List of issues related to all series of amendments to UN Regulation No. 154

GRPE 90th session

Table A6/1 Applicable rules for a manufacturer's declared values (total cycle values)^(a) (as applicable)

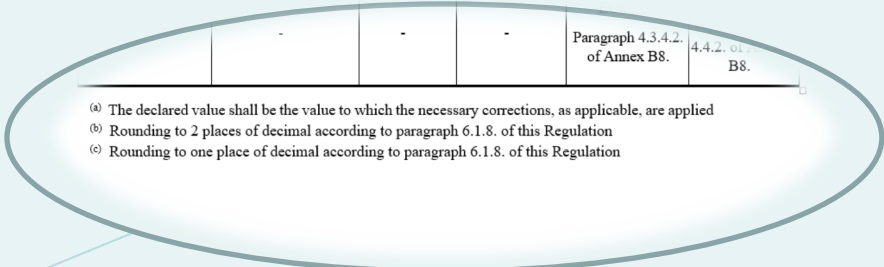
Justification:

- Separate declared values for 3 and 4 phased EC_{WLTC} and PER
- MDV table does not distinguish between 3 and 4 phase here
- Proposal: additional footnote
- Note: slightly different wording for Series 00 & 02

Parameter	For 4 phase RLTP as per Annex B7	For 3 phase RLTP as per Annex B7	For 2 phase RLTP as per Annex B7	Electro-energetic consumption (kWh/kWh)	Active energy consumption (kWh/kWh)
Values stated according to Annex B5	M _{decl}	M _{decl}	M _{decl}	-	-
MDV-PEV ^(b)	-	FC _{MDV}	FC _{MDV}	-	-
MDV-NEV	M _{decl}	FC _{MDV}	FC _{MDV}	-	-
CVC-NEV	CD/CS weight ^(c)	M _{decl}	FC _{MDV}	For Level 1B: EC _{WLTC}	EAER _{WLTC}
		CS	FC _{MDV}	For Level 1B: EC _{WLTC}	EAER _{WLTC}
PEV	-	-	-	EC _{WLTC}	PER _{WLTC}

^(a) The declared value shall be the value to which the necessary corrections, as applicable, are applied
^(b) Rounding to 2 places of decimal according to paragraph 6.1.8. of this Regulation
^(c) Rounding to one place of decimal according to paragraph 6.1.8. of this Regulation

Annex B8 → Deletion of “Level 1A only” in 1.4.2.2.

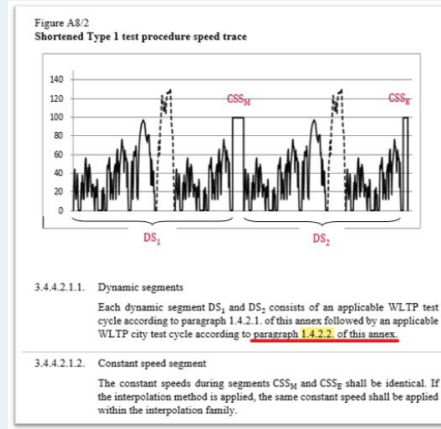
Justification:

- “Level 1A only” makes no sense in 1.4.2.2.
- It could lead to the interpretation in paragraph 3.4.2.1.1. that dynamic segment for Level 1B just consists out of applicable WLTP test cycle only as paragraph 1.4.2.2. is not applicable
- Furthermore, restriction to Level 1A not required in paragraph 1.4.2.2. because anyway stated in the whole calculation chapter that city cycle not applicable for Level 1B, e.g. in front of Table A8/11

- Delete “Level 1A only” in paragraph 1.4.2.2.

1.4.2.2. → ~~Level 1A only¶~~
~~Applicable WLTP city test cycle¶~~
~~The Class 3 WLTP city test cycle (WLTC_{city}) is specified in paragraph 3.5. of Annex B1.¶~~
